Memo:

RE: Glade Spring Crossing rezoning requests

This memo is provided to request consideration for utility separation during design of Glade Spring Crossing and to request removal of the development parcels from the Tom's Creek Basin Unsewered Service Area.

**TYPICAL ROAD CROSS SECTION
AND UTILITIES SEPARATION**
(NOT TO SCALE)

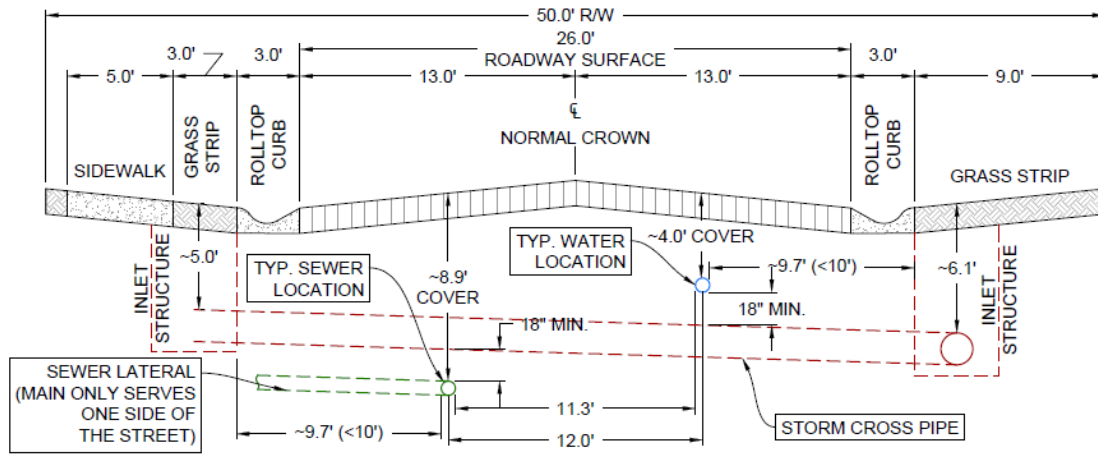
- 2) The applicant requests a change to the Sanitary Sewer and Water Specifications; A 10' separation is required between water, sewer, and storm drain utilities

- a) The applicant a change to allow for the separation in water and sewer utilities from storm structures by a measurement of 8 feet rather than 10 feet. This is for the **Stormwater structures ONLY in the South section**. This will allow for utilities to generally remain in the right-of-way as opposed to going in front yards, under driveways and conflicting with street trees. The right of way is clear from private yard obstacles and is the preferred location for utilities. However, storm inlet structure locations are dictated by street widths, and these cannot meet the 10' separation where curb/gutter is installed. 24' and 26' paved street widths are proposed as part of the development. Given the street and right-of-way widths, an exception is needed as there is inadequate space within the street to contain water, sewer, and storm utilities while maintaining 10' horizontal separation between each. The risk of sanitary sewer contamination through a concrete stormwater structure is very minimal. The applicant feels this risk is smaller than placing sewer or water in a front yard of a residence that may have tree roots or fencing, etc. The typical section from the application is included below
